July 6, 2023
Project No. 3262-1L2

**RE: RESPONSE TO COUNTY REVIEW
COMMENTS & REPORT UPDATE
PROPOSED RESIDENCE
WATERS PROPERTY
APN 351-42-004, PEACOCK COURT
SANTA CLARA COUNTY, CALIFORNIA**

GEOLOGIC CROSS-SECTION B-B'	
	WATERS RESIDENCE APN 351-42-004 PEACOCK COURT SANTA CLARA COUNTY, CALIFORNIA	
PROJECT NO. 3262-1L2	JULY 2023	FIGURE A-7 (REVISED)

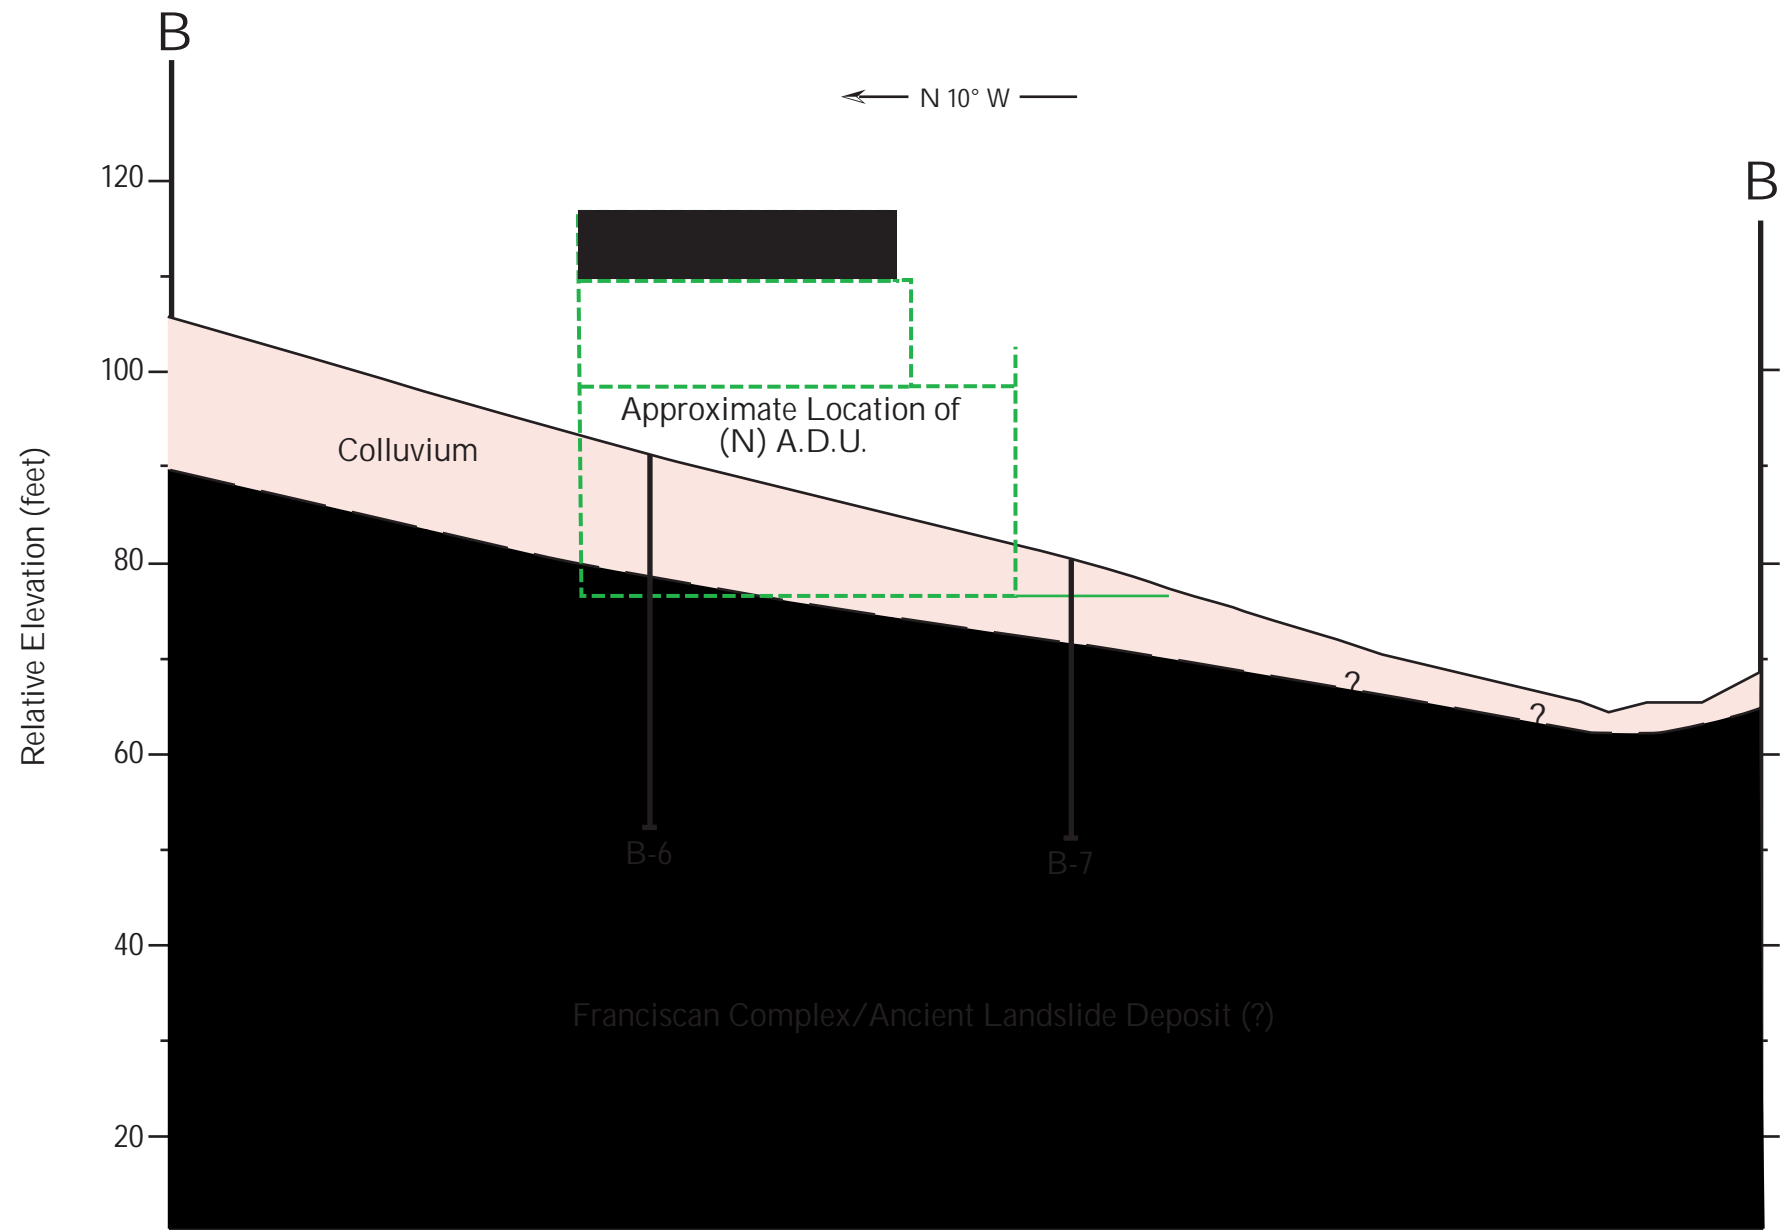
The County's January 25, 2022 staff memorandum notes that the project was initially denied in November 2021, in part based on review of our limited geologic and geotechnical investigation report dated July 11, 2017. The 2017 investigation included five exploratory borings and, based on those borings, a recommended house site was identified in the area of the currently proposed residence. The report described the drainage ravine that extends along the southern property line and identified a potentially unstable area above the ravine based on exploratory borings and computer-aided slope stability analyses. The site plan included in the 2017 report included a recommended building setback line 130 feet from the centerline of the ravine. The memorandum notes that our April 23, 2020 design-level geotechnical report was submitted as part of the appeals process. The memorandum notes that the Geologic Cross-Section A-A' presented in our 2020 report did not depict the proposed improvements and, as a result, it was unclear if the proposed construction extended into the building setback zone. Although not specified in the memorandum, the proposed A.D.U. also extends into the 130-foot building setback zone shown in our 2017 report.

Attachments: Figure A-2 (Revised), Partial Site Plan & Engineering Geologic Map
Figure A-6 (Revised), Geologic Cross-Section A-A'
Figure A-7 (Revised), Geologic Cross-Section B-B'
Figure A-9 (Revised), Pseudo-Static Slope Stability Analysis Along Cross-Section A-A'
